NBSIR 83-2693

DEVELOPMENT OF DRAFT CONSTRUCTION SAFETY STANDARDS FOR EXCAVATIONS

Felix Y. Yokel

April 1983

Figure 2. Allowable configurations of sloped excavations
(cases II, III, and IV are for short-term excavations)

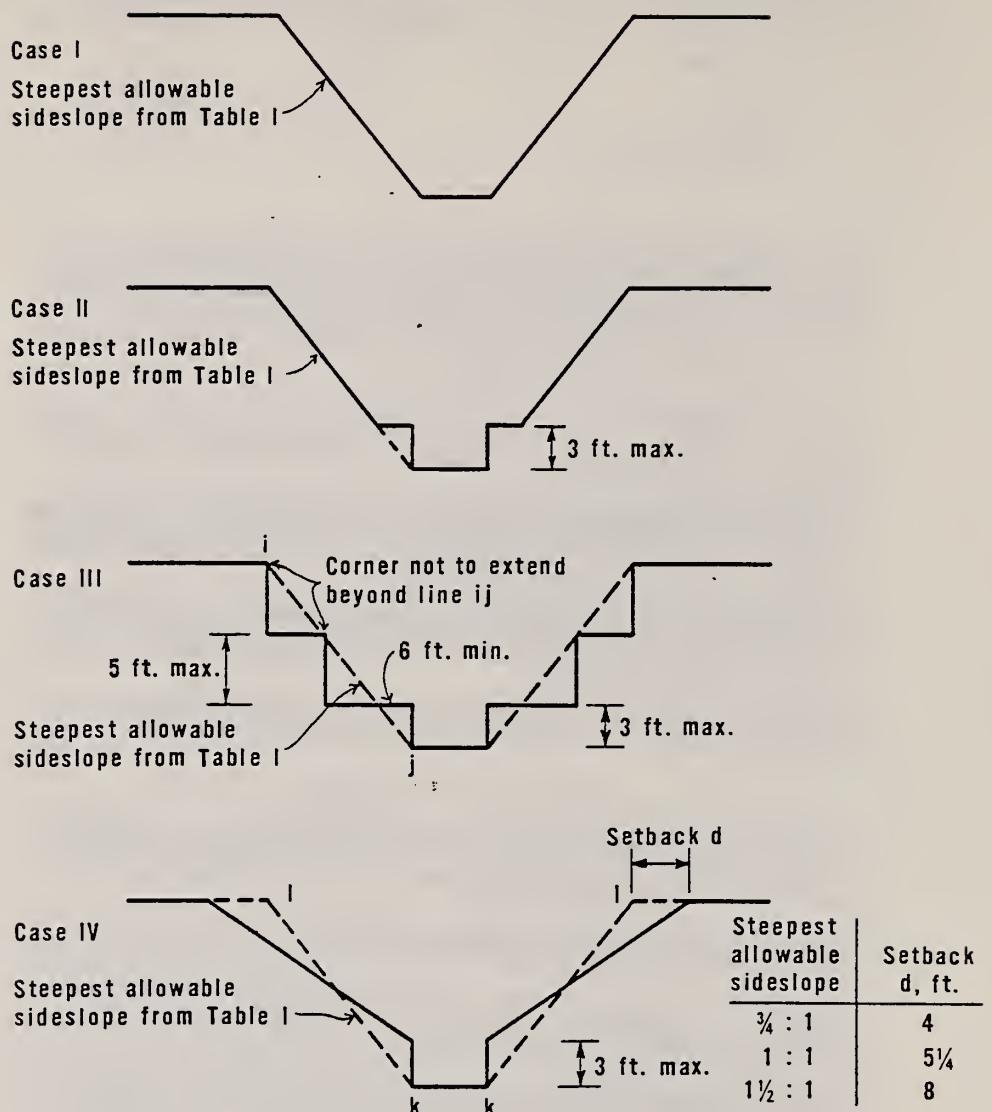
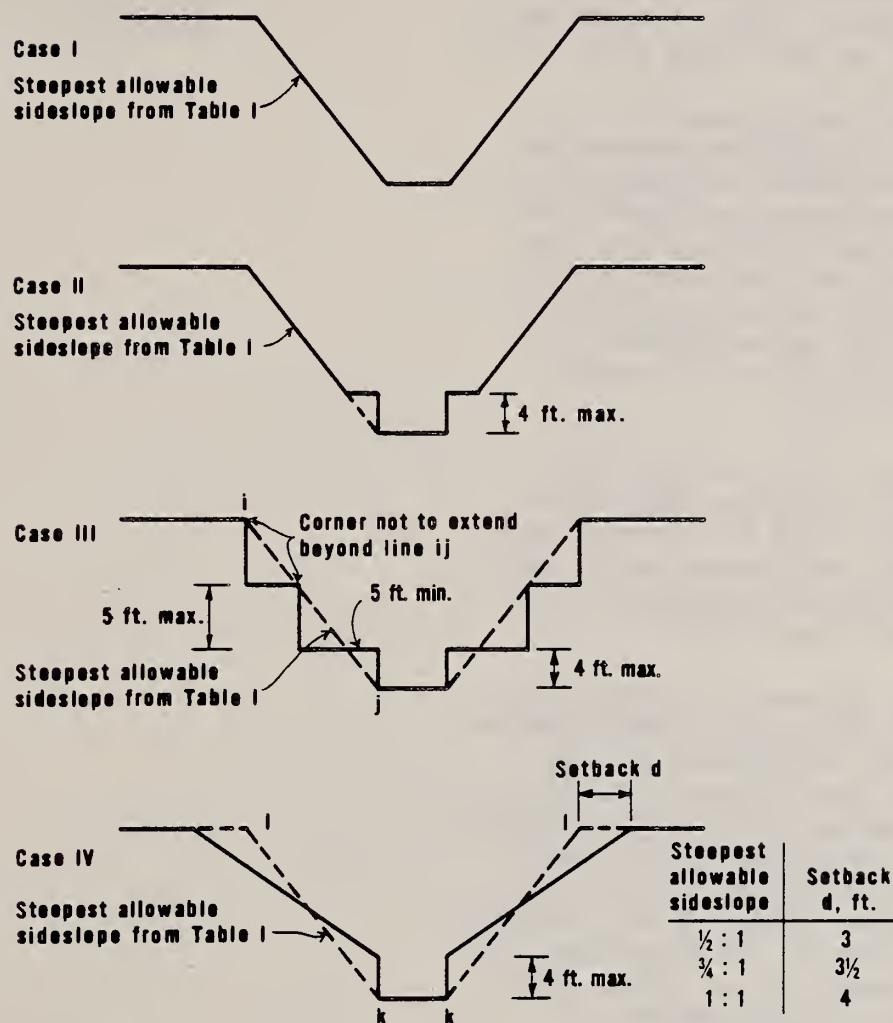
In the Dallas workshop, it was suggested by some contractors to increase the bank to 5 ft (workshop memo). AFL-CIO recommended to leave the allowable height at 3 ft. The point was made that if a large pipe is laid it would provide workers protection against collapse of the bank next to the work area.

6. Page 12. Figure 2: Should the allowable bank next to the work area in Cases II, III and IV be increased to 4 ft? Should "Case IV" be limited to excavation by trenching machines?

The revised sketch is a suggestion rather than a recommendation. It is recommended that industry try to reach agreement on the height of the allowable bank.

Figure 3. Determination of Adjusted Depth

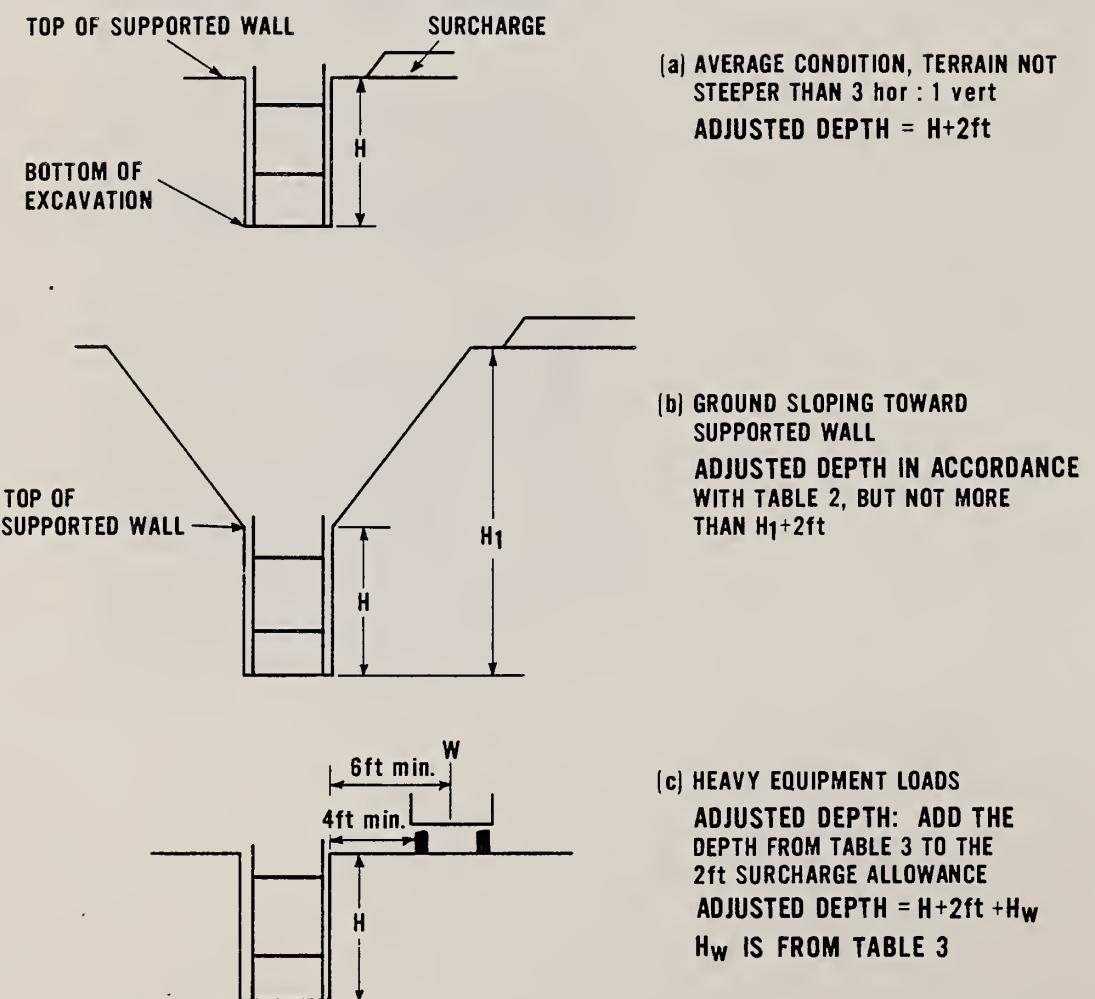
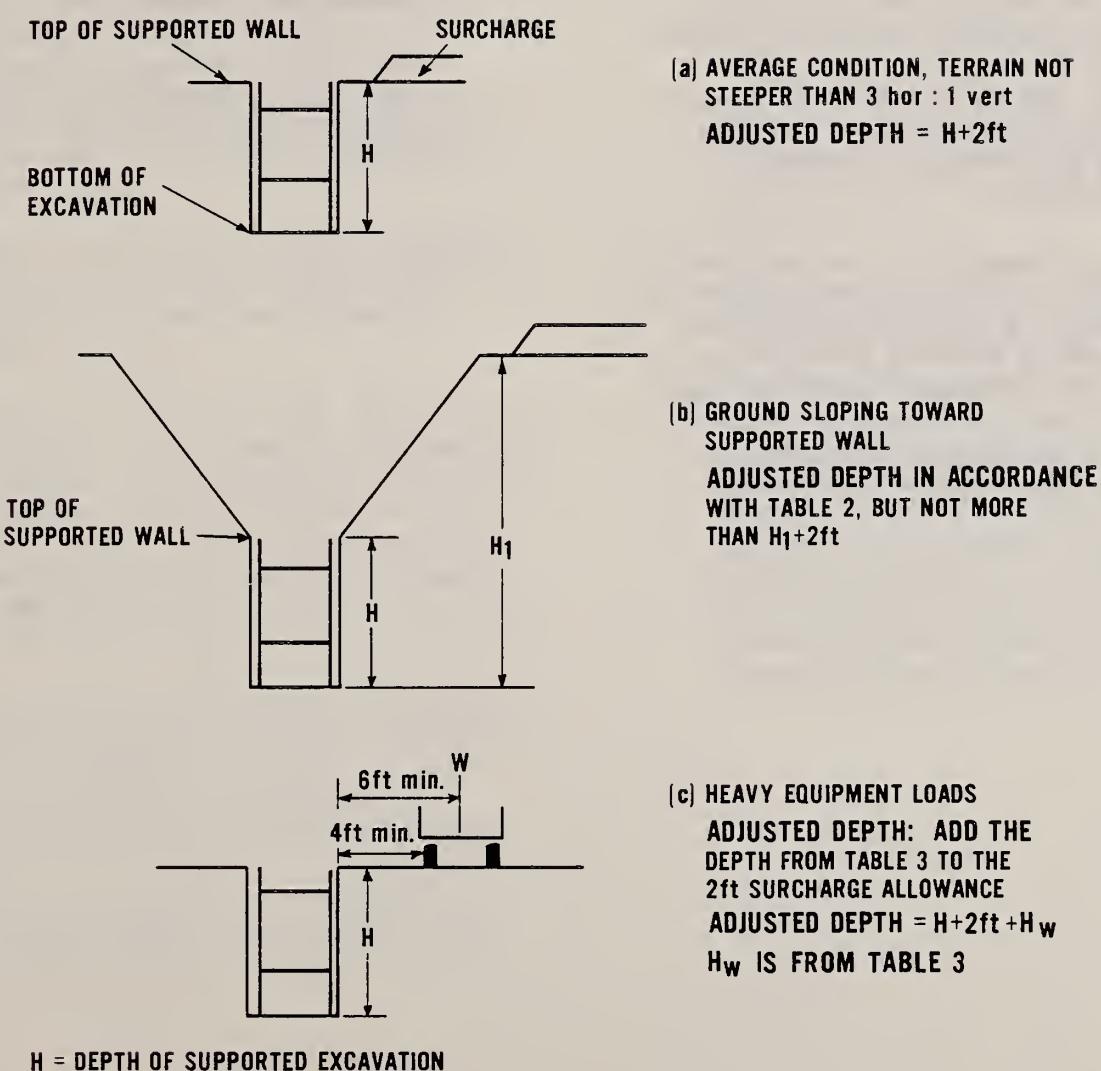
(4)(i) Even though b. and c. require some skill, their application should not be too difficult for a competent person to handle. The alternative of a need to consult a qualified person who is not on the job is even less attractive. The AFL-CIO suggestion of increasing the surcharge requirement in a., and in return eliminating b. and c., would mean in practice that in case b., a backslope of maximum 4 ft. height (H_1 in figure 3b = 4 + 4 ft) could be allowed, and equipment of maximum 20,000 lb. With higher backslope and heavier equipment, an engineer (qualified person) would have to be consulted. If this is acceptable, OSHA could go that route.

TABLES 2 and 3 NO CHANGE RECOMMENDED
